AGENDA ITEM SUMMARY REPORT

APPLICATION: Coastal Development Permit 2-22 (CDP 2-22), Design Review 7-22 (DR 7-22); Parcel Merger 1-2022 (MGR 1-22), Application Date 3-14-2022

APPLICANT: Best Development

LOCATION: 825, 845, & 851 S. Franklin Street; 018-120-47, 018-120-48, & 018-120-49

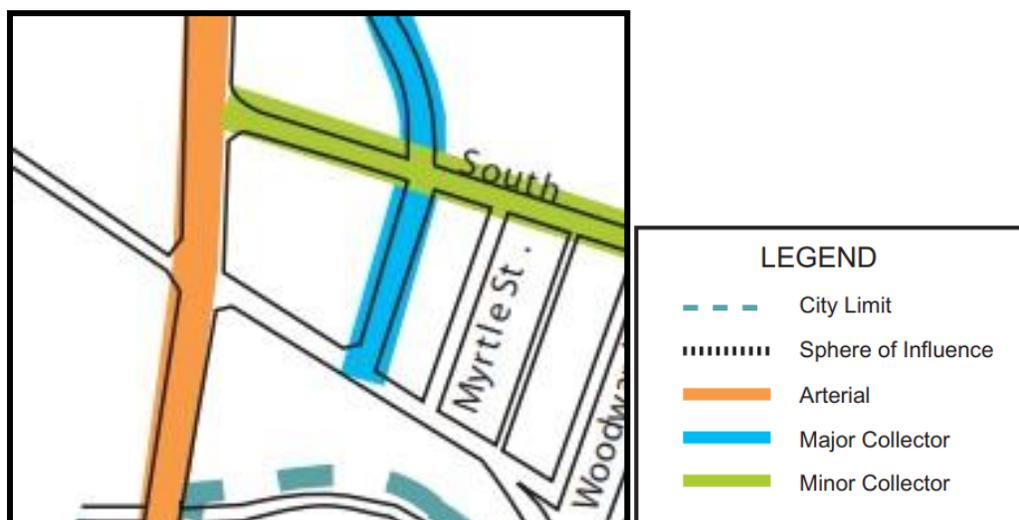
Additionally, the landscaping plan contains several plant species that are non-native and may not be drought tolerant, which is not consistent with Policy OS-11.8 Landscape with Native Plant Species. The landscaping plan also includes 24 Monterey Cypress trees, which are non-native to our County and have a tendency to grow very large and become dangerous over time. The Planning Commission recommends Special Condition 1c, d and e to require an alternative tree species and a revised landscaping plan. [The Planning Commission expressed interest in preserving the two existing Monterey Cypress Trees, if feasible. Additionally, backflow devices are required for new projects with fire sprinklers systems and unfortunately the placement of such devices often occurs as an afterthought, and they often mar otherwise compliant site landscaping. Therefore, MJC recommends Special Condition 1b be modified as follows to require appropriate location and screening of the backflow devices.](#)

Special Condition 1b: The Applicant shall resubmit the landscaping and parking plans for Community Development Director approval. The revised parking and landscaping plan shall:

- [Comply with the required landscaping setback of 15 feet for parking lots by modifying the parking lot to ensure adequate setback for the two parking spaces on the southwest corner of the lot \(Section 17.34.050C4a\);](#)
- Contain drought tolerant native species;
- [Preserve the existing Monterey Cypress Trees and the Shore Pine on site,](#)

as feasible, and replace the proposed 24 Monterey Cypress Trees in the Landscaping Plan with a locally native tree species.

- Comply with the California Model Water Efficient Landscape Ordinance (MWELO).
- Include the placement of the backflow device, which shall be fully screened from view by landscaping shrubs.

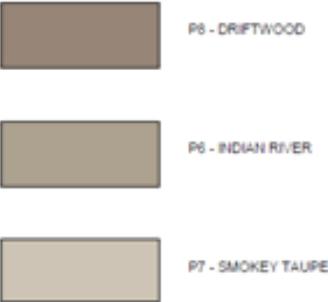
The Planning Commission recommends Special Condition 24, with proposed strike out, to ensure that building materials on the North and East façade of the building match that of the south face.

Special Condition 24: The Applicant shall replace/cover all smooth surface CMU block on the east and north elevation of the building with one of the higher-grade materials (~~fish scale hardipanel~~) which are proposed for the South and West facade of the building.
